ADDENDUM NO. 1

ISSUE DATE: **September 05, 2024**

RE: **CHAMBERLIN L&S SONGS PHYSICS LAB RENOVATION
UNIVERSITY OF WISCONSIN-MADISON
MADISON, WISCONSIN**

UW-Institution Project No. 0055-2346
UWSA Project No. A-23-012

Chamberlin L&S Songs Physics Lab Renovation
UW Madison
1150 UNIVERSITY AVE, MADISON, WI 53706
SHEET TITLE: NEW WORK ENLARGED PLANS - LEVEL 03 & LEVEL 04 - ELECTRICAL

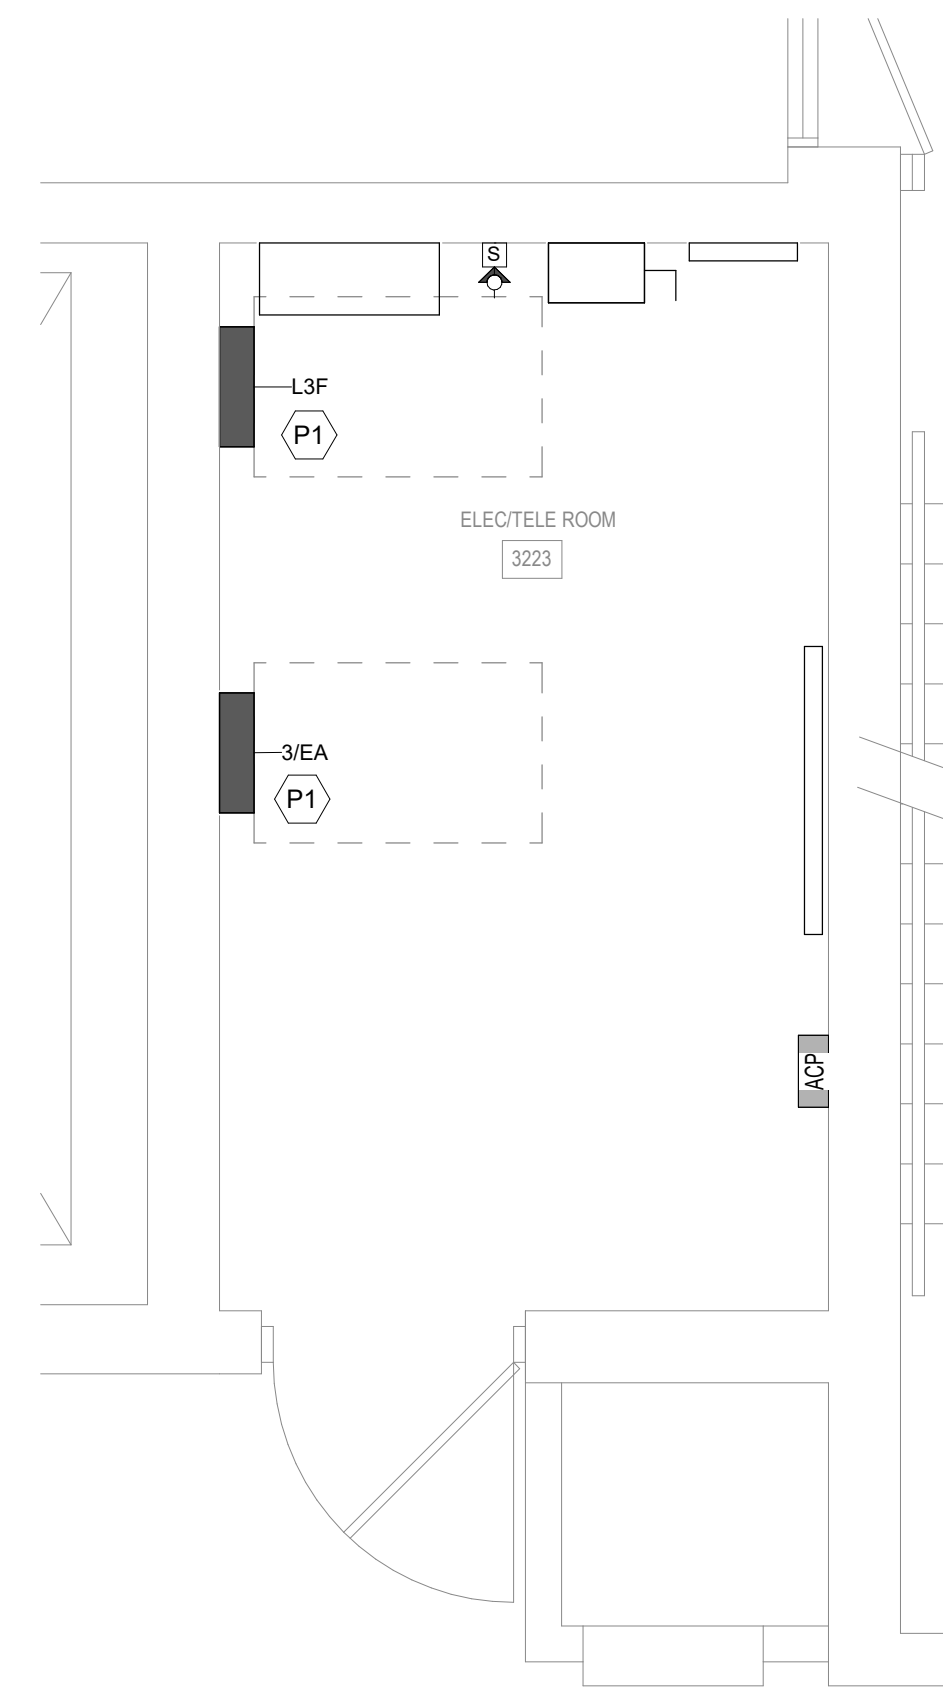
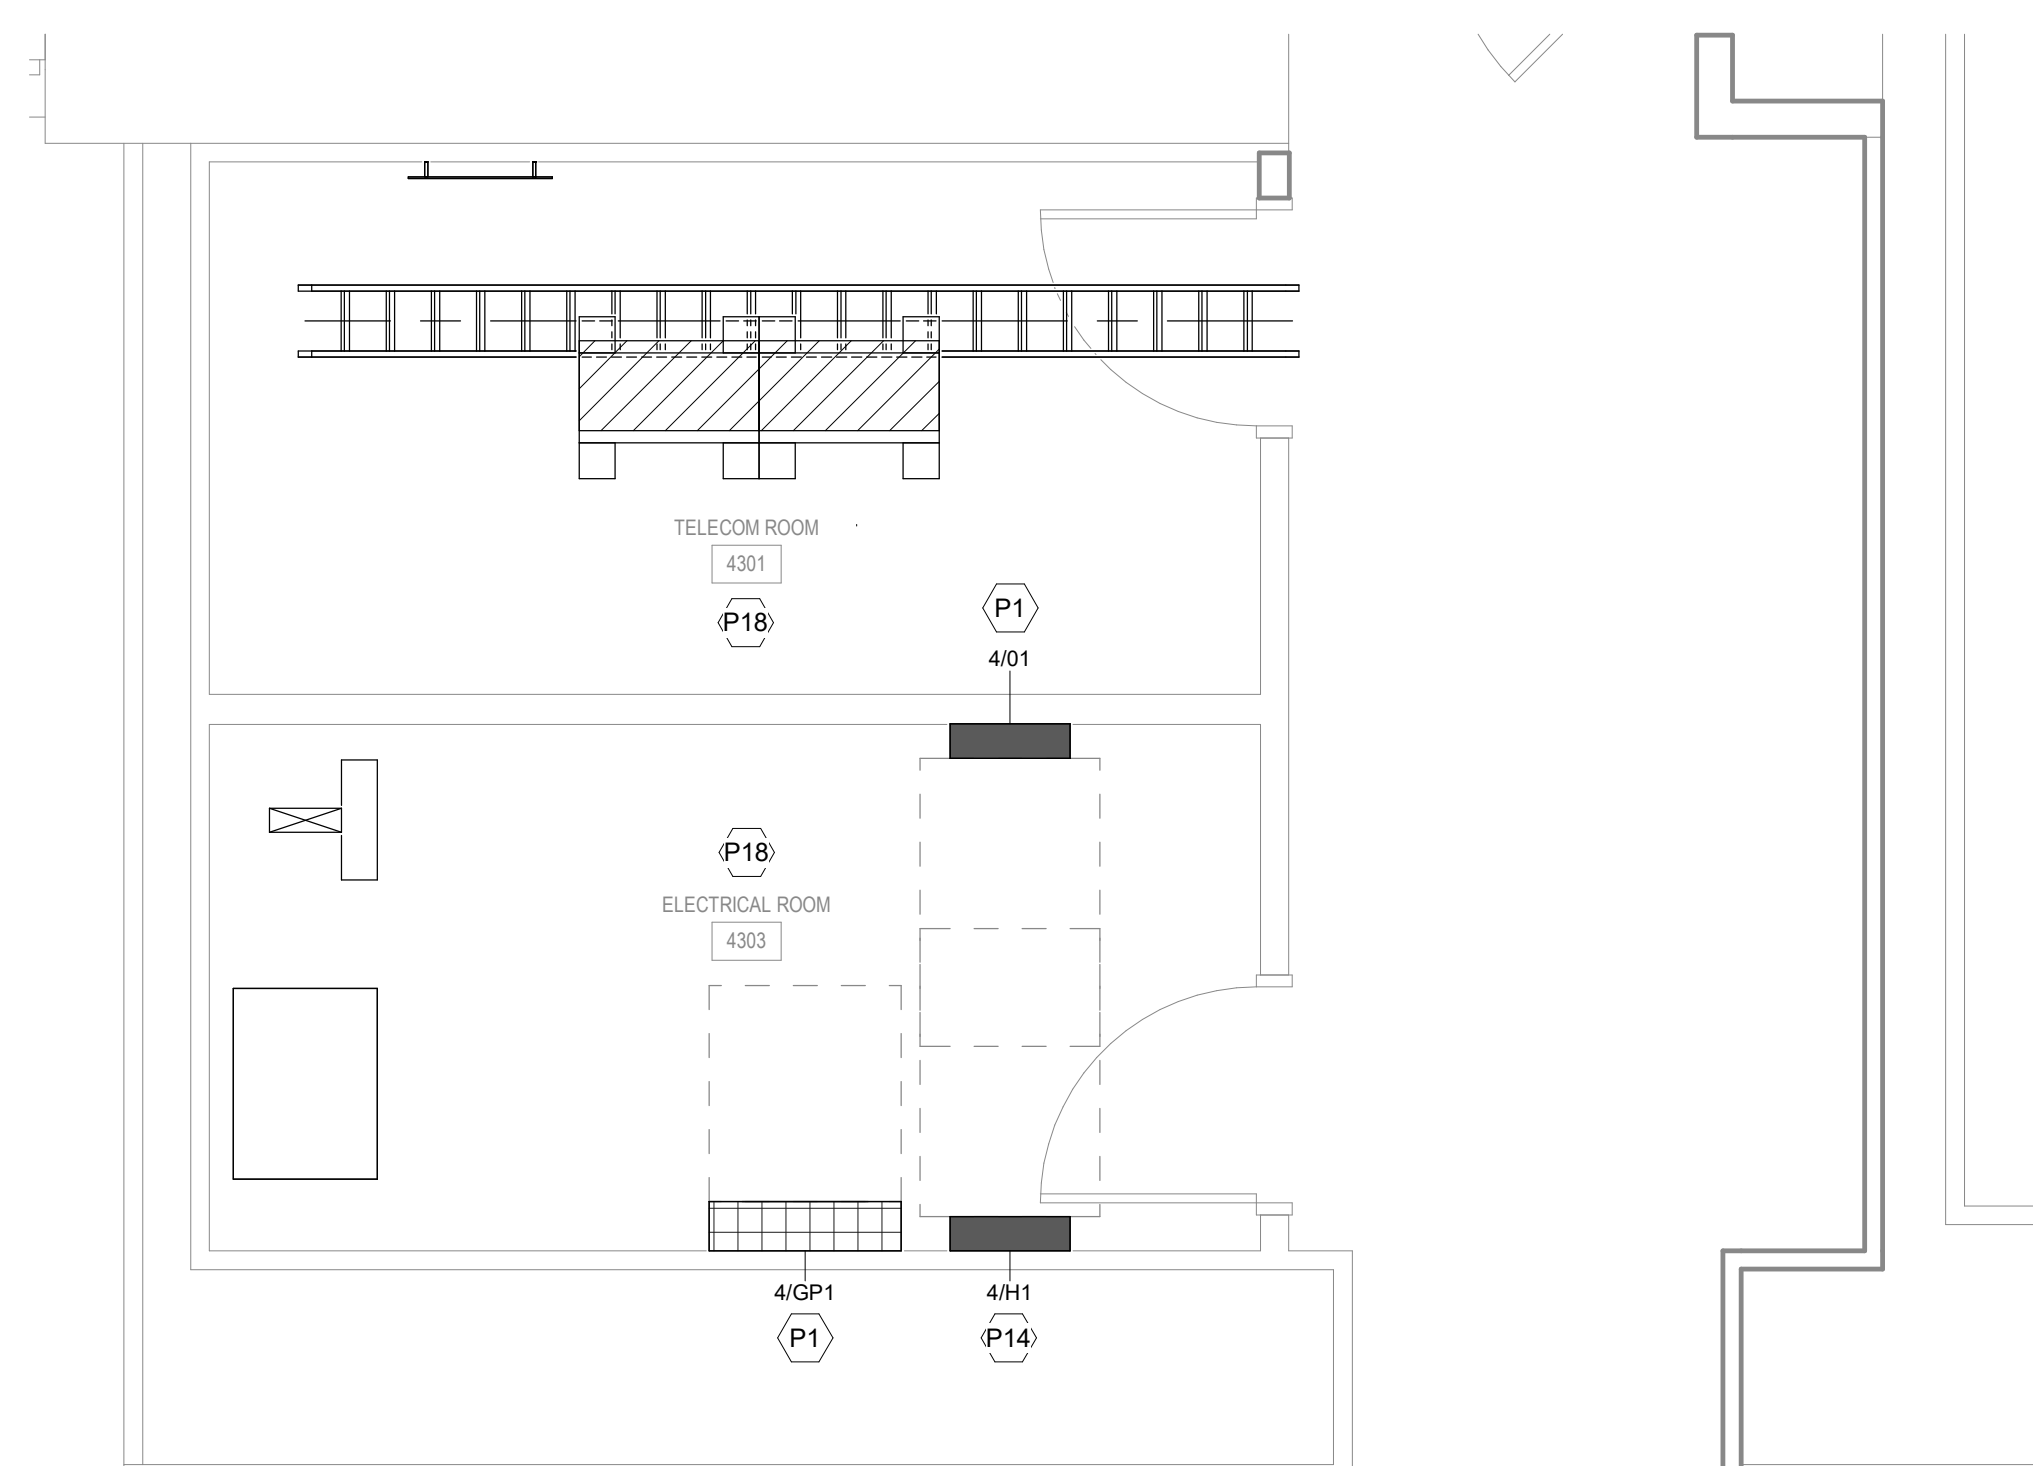
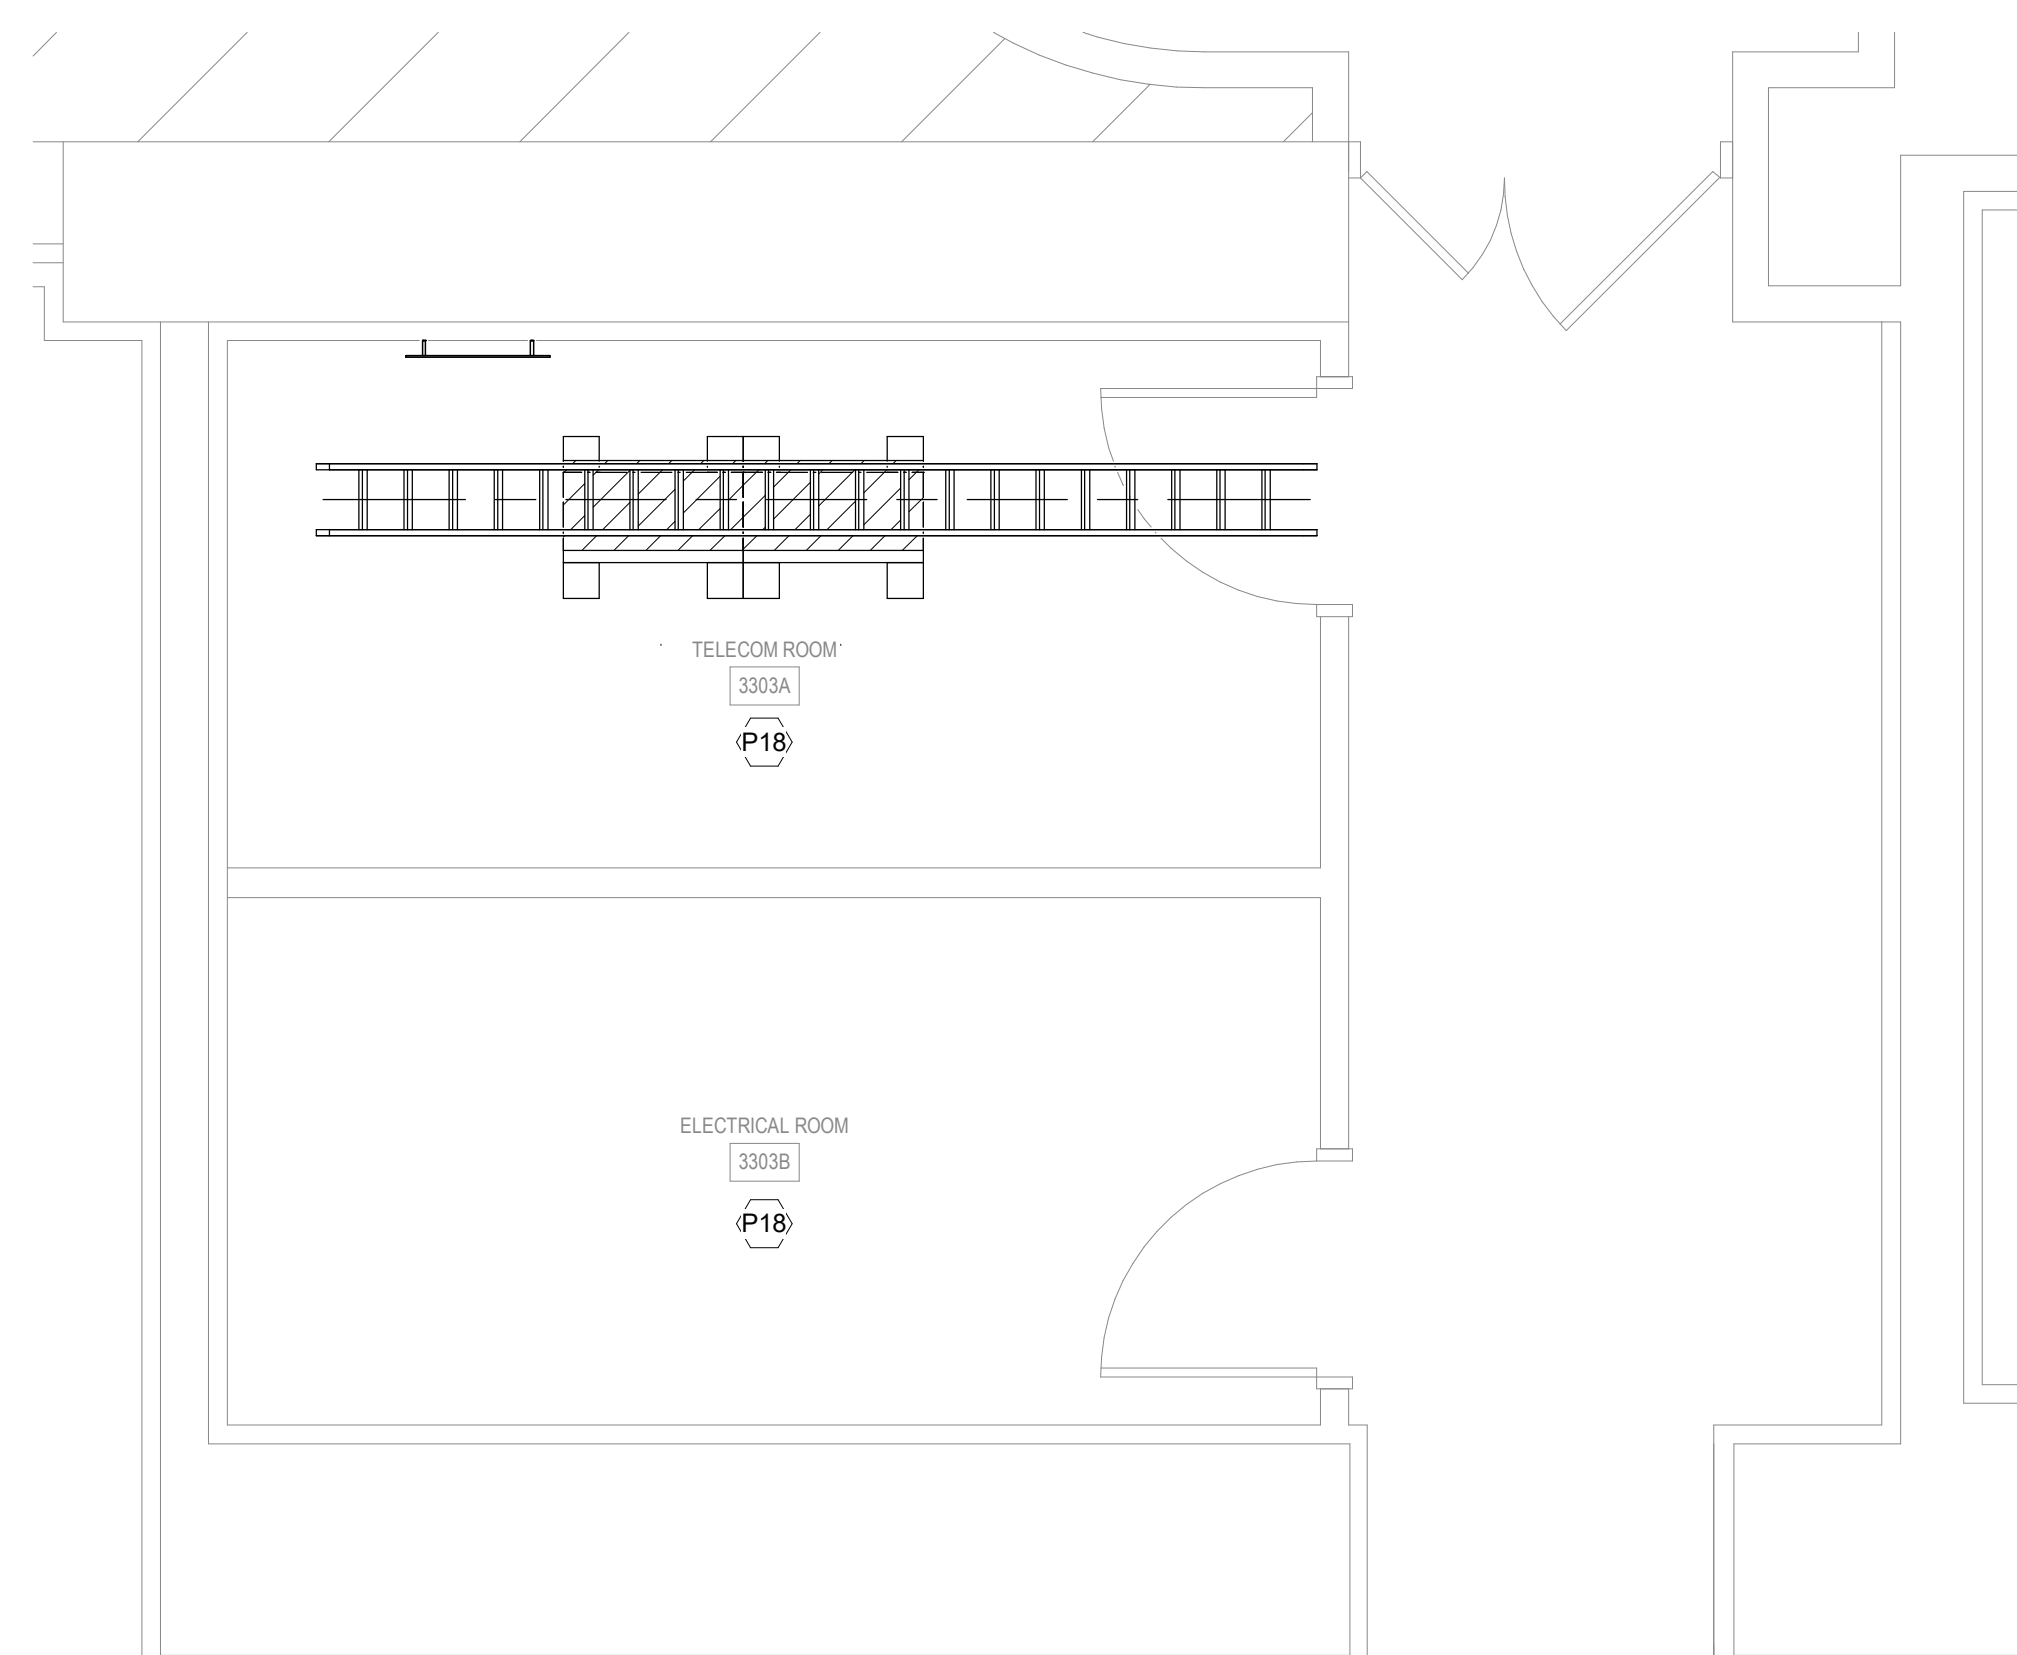
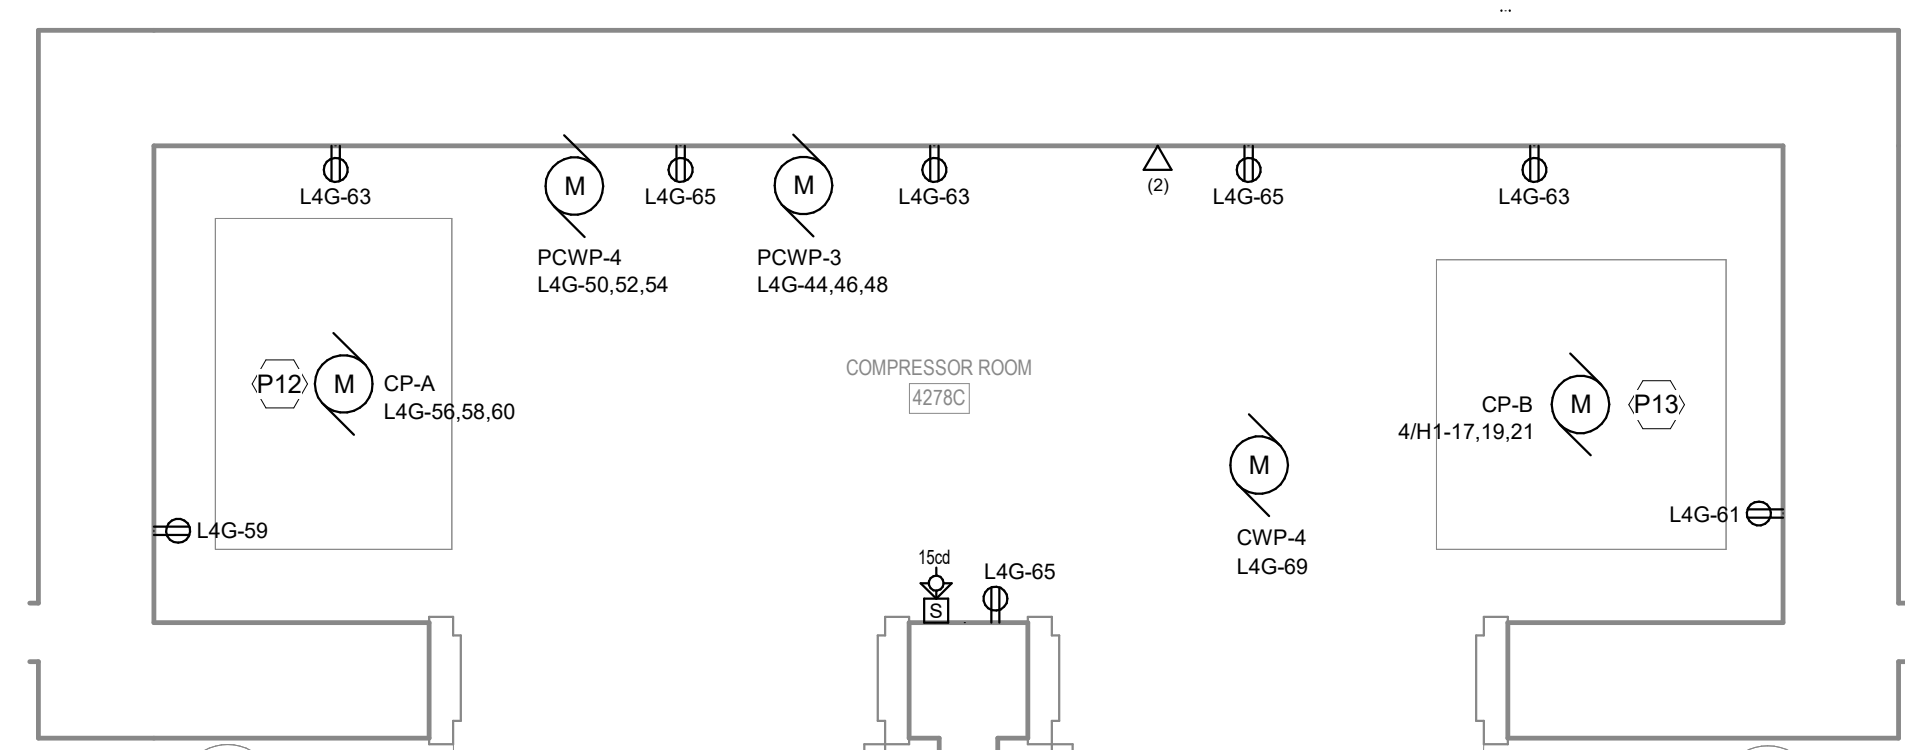
- 5. Sheet E301 – NEW WORK ENLARGED PLANS – LEVEL 03 & LEVEL 04 - ELECTRICAL
 - a. Revise power general note to clarify the number of current carrying conductors allowed to be installed in a single conduit prior to conductor derating.

- REFER TO SHEET E000 FOR ALL SYMBOLS, ABBREVIATIONS, AND DETAILS.
- THE CONTRACTOR MAY INSTALL UP TO THREE (3) CURRENT CARRYING CONDUCTORS IN A CONDUIT. WHEN UTILIZING ONLY #12 CONDUCTORS, THE CONTRACTOR MAY INSTALL UP TO SIX (6) CURRENT CARRYING CONDUCTORS IN A CONDUIT. LOADINGS ARE BASED ON THWN INSULATION, 40°C AMBIENT WITH DERATINGS FOR TEMPERATURE AND UP TO THREE (3) CONDUCTORS IN A CONDUIT. CONTACT THE ENGINEER FOR WIRING IN OTHER CONDITIONS TO ACCOUNT FOR CONDUCTOR DERATING. NEUTRAL CONDUCTOR SHALL BE CONSIDERED A CURRENT CARRYING CONDUCTOR IN UNBALANCED, 3-PHASE APPLICATIONS.
